## NINE MILE POINT NUCLEAR STATION

**SUBJECT:** Nine Mile Point Nuclear Station  
Unit No. 2; Docket No. 50-410

Response to Request for Additional Information Regarding Nine Mile Point Nuclear Station, Unit No. 2 – Re: The License Amendment Request for Extended Power Uprate Operation (TAC No. ME1476) – Anticipated Transient Without Scram Simulator Tests and Net Positive Suction Head for Emergency Core Cooling Systems

Figure 55  
Transient Test EPU Isolated ATWS MELLLA

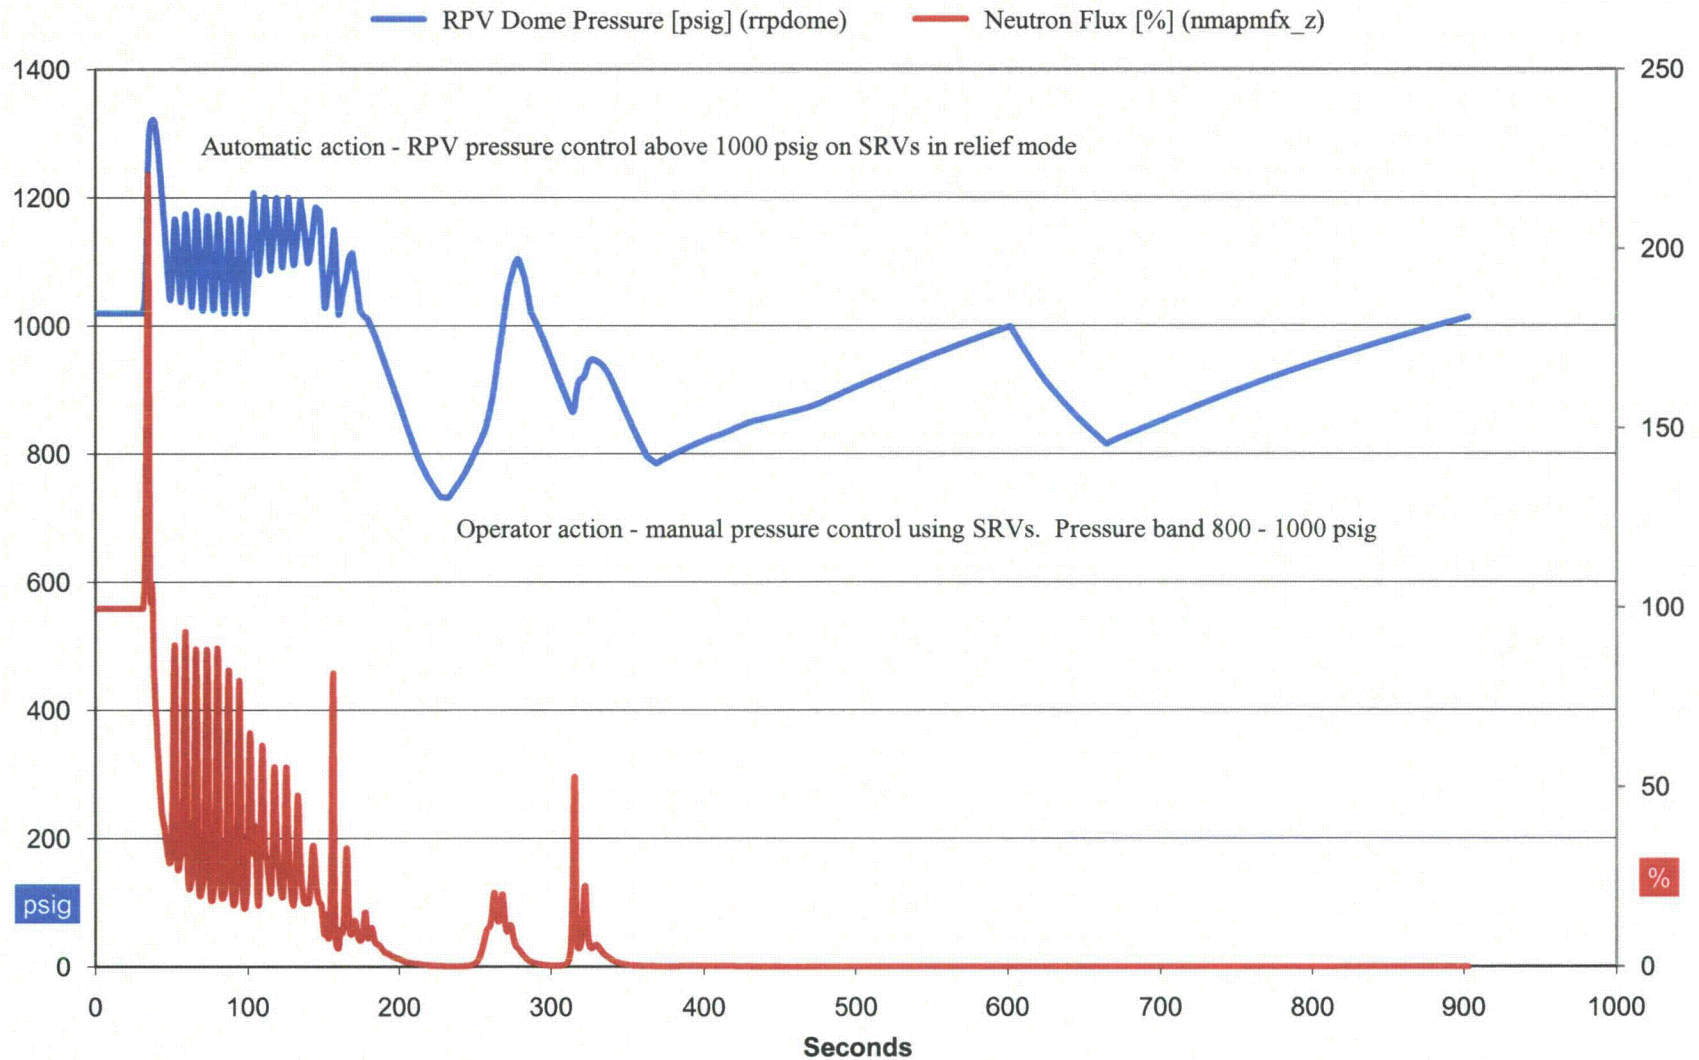
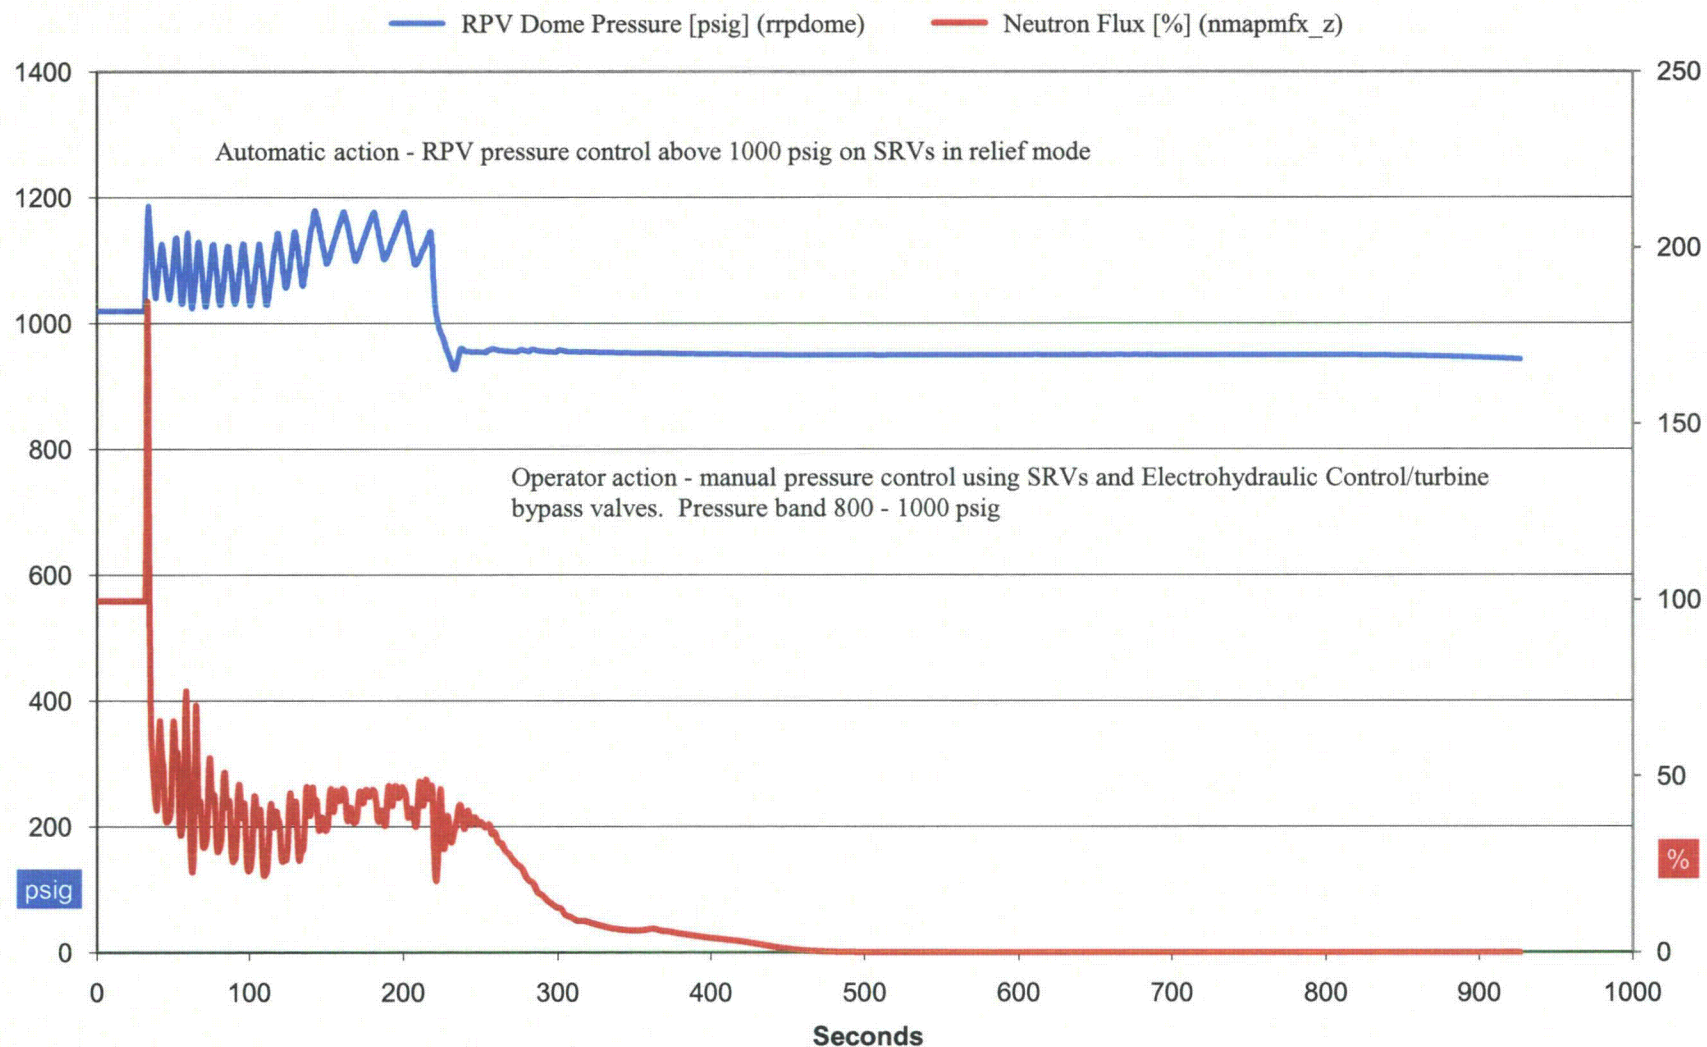
- 1) Provide the sequence of both events with the transient response(s) corresponding to ATWS emergency operating procedure actions (e.g., turbine trips, recirculation pump trips, turbine bypass valves open, power increases, water level reduction, standby liquid control system injection, to steady state/oscillation under control, etc.)*
- 2) For clarity of the data tables for both the MSIV closure and turbine trip ATWS EPU events, provide the full name/nomenclature with description or definition of each column field (e.g., rrp dome, nmapmfx\_z, fws1a101, etc.).*
- 3) In addition to the [Reactor Pressure Vessel] RPV Pressure vs. Time plots in both events, please include an overlay plot of Power versus Time (i.e., show power oscillations/response corresponding to the RPV pressure response).*

Figures 55 and 56 provide overlay plots that show RPV pressure and reactor power versus time for both of the ATWS Simulator exercises.

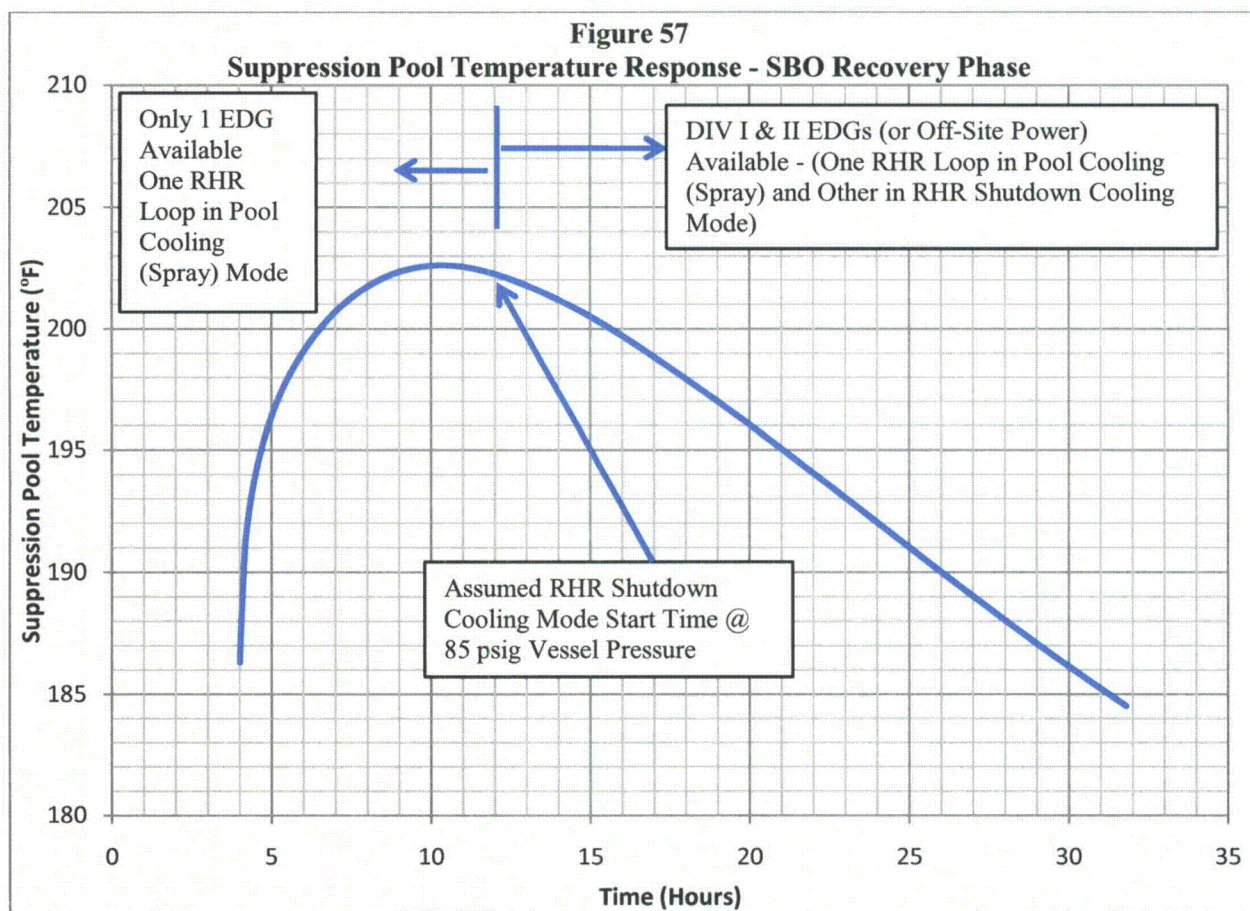
*The technical staff requests additional clarification in NMPNS' RAI response dated May 9, 2011, regarding the operation of the pumps during [a] SBO, particularly after the coping period. The RAI response stated that the SBO scenario was not included in the licensee's evaluation as the [Reactor Core Isolation Cooling] RCIC pump is relied upon during the coping period. Nothing was said in the response about operation of other pumps past the SBO coping period.*

With the assumptions noted above, a simple suppression pool heatup estimate is shown in Figure 57. The suppression pool temperature increases over a two to three hour period to above 200°F, but is predicted to remain below 208°F for the duration of the recovery period. The reactor pressure is reduced below the assumed 85 psig after approximately 12 hours from SBO initiation (8 hours after the initial 4-hour coping period). Consistent with the ASDC assumptions, the 1.6 margin ratio is maintained with suppression pool temperature below 208°F. Therefore, the 1.6 margin ratio is maintained assuming no containment accident pressure and conservatively assuming no credit for the increased suppression pool level predicted for SBO during the recovery phase with RCIC taking suction from the CST.

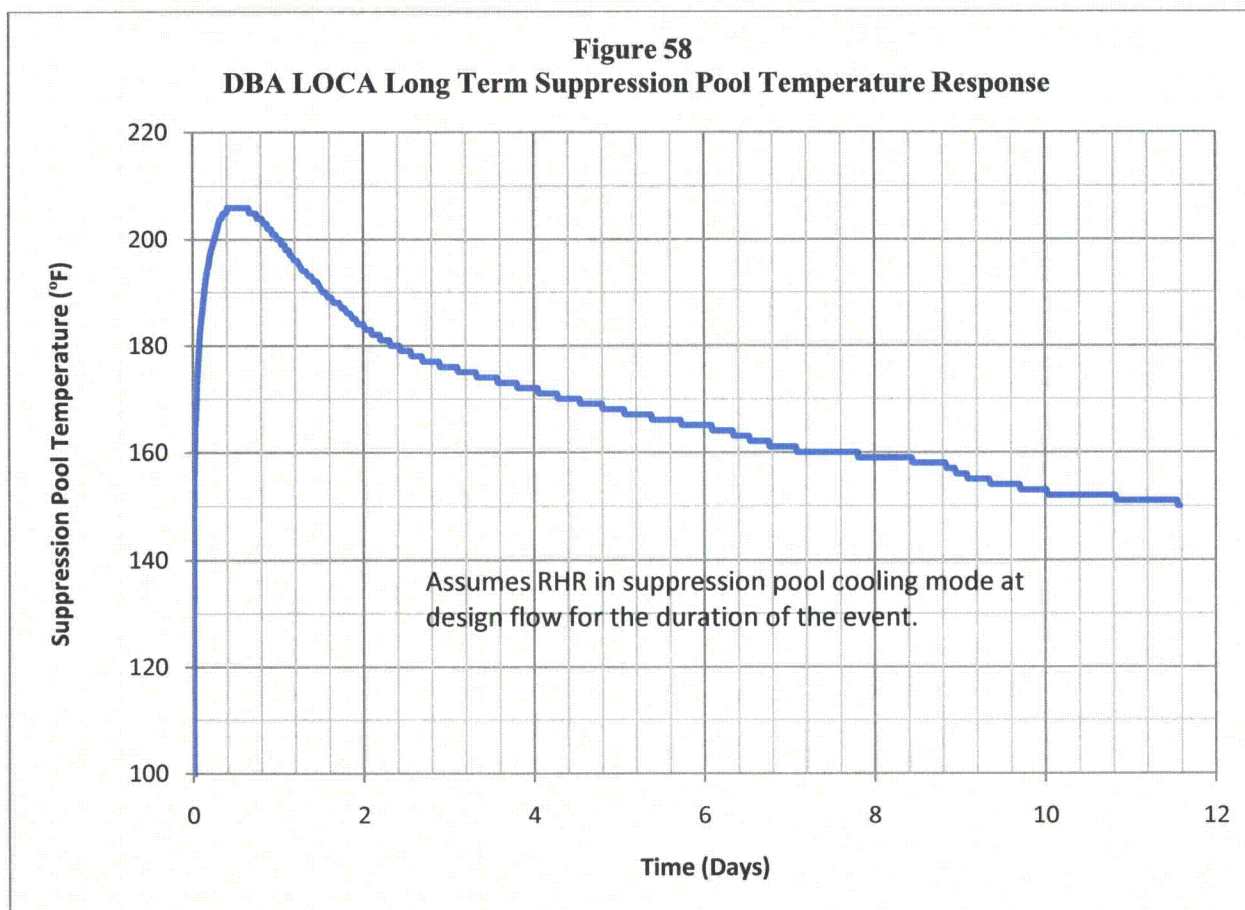
*In letter dated May 9, 2011, it was stated that the [Low Pressure Coolant Injection] LPCI ([Residual Heat Removal] RHR) pumps could operate at margin ratio of less than 1.6 for approximately 839 minutes (~14 hours) for [Design Basis Accident – Loss of Coolant Accident] DBA-LOCA and 376 minutes (~6.3 hours) for [Alternate Shutdown Cooling] ASDC. It was further stated that the operational times were based on the tabular values for suppression pool temperature versus time developed to generate the graphs in NMP2 EPU LAR dated May 27, 2009. However, the graphs that were included in the EPU LAR only go up to  $10^5$  seconds (~28 hours). It is not clear how long a period did NMPNS evaluate the operation of the pumps. During long-term cool-down, the pumps could operate at a flow rate higher than during short-term, thus potentially reducing [Net Positive Suction Head] NPSHA. Please provide additional information to assure the staff that NMPNS has considered all factors that could potentially affect the margin ratio during long-term cooling in arriving at the above mentioned times.*

Figures 58 and 59 provide the long term suppression pool temperature versus time for the DBA-LOCA and ASDC scenarios. The evaluated time periods for the DBA-LOCA and ASDC scenarios are approximately 12 days and approximately 2.5 days, respectively. Both scenarios assume that the RHR pumps are operating at the design basis suppression pool cooling flow rate for the duration of the event. The NPSH margin assessment conservatively applied the design basis runout flow assumption.

For the DBA-LOCA and ASDC scenarios, the NPSH margin ratios are above 1.6 for suppression pool temperatures below 202°F and 208°F, respectively. (Note: The difference in maximum temperatures is due to assuming a debris loading on the strainer for the DBA-LOCA case and assuming no debris loading on the strainer for the ASDC case.)
